Delegated Report

Householder Planning Application

Planning Application No: 20220810

Description: Erection of a two storey rear extension.

Existing and Proposed Plans for this Application (202208010)

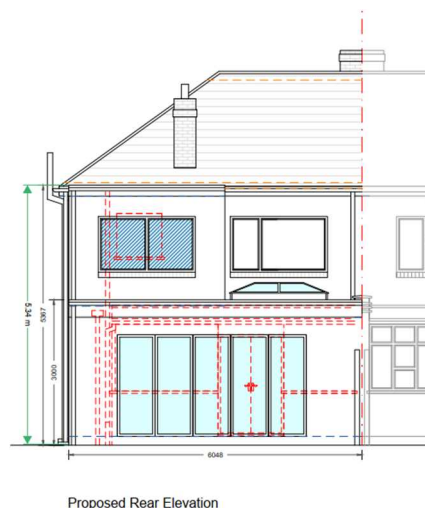
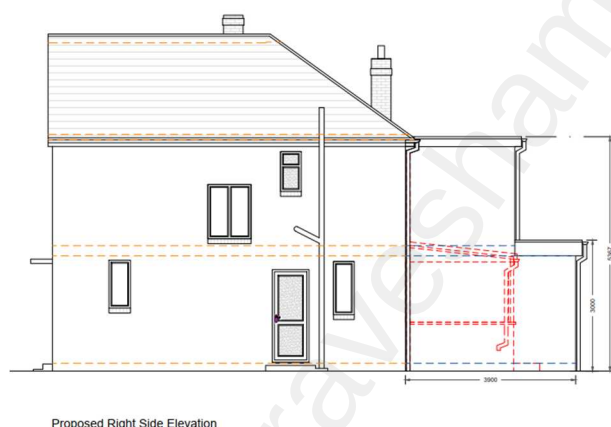
According to the plans, this application proposes the demolition of the existing conservatory and the erection of a part single, part two storey flat roof rear extension. The development would make space for internal layout changes, a new utility room at ground floor level and an enlarged bathroom and bedroom at first floor level.

As evidenced by the proposed plans above, the development would be a bulky incongruous addition to the dwellinghouse and is considered poor design. The flat roof at second floor level is not sympathetic to the existing roof form and has an incongruous appearance which would overwhelm the property. Therefore, the two storey element is considered contrary to Gravesham's Design SPG (2021).

The proposed external materials; rendered walls and windows to match the existing are considered acceptable, however, the GRP flat roof on the two storey extension is not.

Overall, the proposed development, with regards to other development being undertaken on site is considered to be overdevelopment which would result in a bulky and disproportionate addition that is not subservient and will overwhelm the original dwellinghouse. The flat roof at second floor level is not sympathetic and does not integrate well with the existing dwelling or surrounding properties. Therefore, the development is contrary to Gravesham's Householder Extensions/Alterations Design Guide (Design SPG) (2021), Policy CS19 (Development and Design Principles) of Gravesham's Local Plan Core Strategy (LPCS) (2014) and Section 12 of the National Planning Policy Framework (NPPF) (2021).

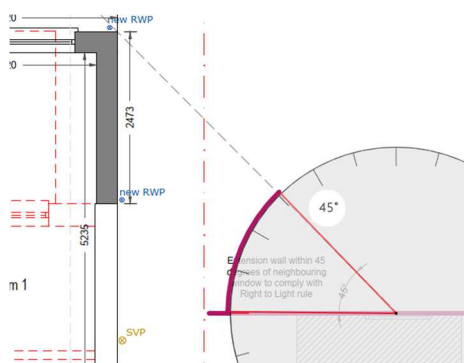
The proposed room sizes comply and exceed Gravesham's SPG 2 - Residential layout guidelines (RLG) (2020). In addition, the RLG (2020) sets out the minimum garden area and depth requirements post development. As aforementioned in this report, the previous application 20220679 and the applicant have indicated the property has 3 bedrooms. As per the RLG (2020), the garden area should be 60.00sqm and depth should be 10.00m. The proposed block plans show the garden depth would be approximately 15.29m and area would be approximately 95.51sqm, and therefore would comply with the guidance. As such, the development is considered to safeguard the amenity of future occupiers in accordance with Policy CS19 (LPCS) and Section 12 (NPPF).
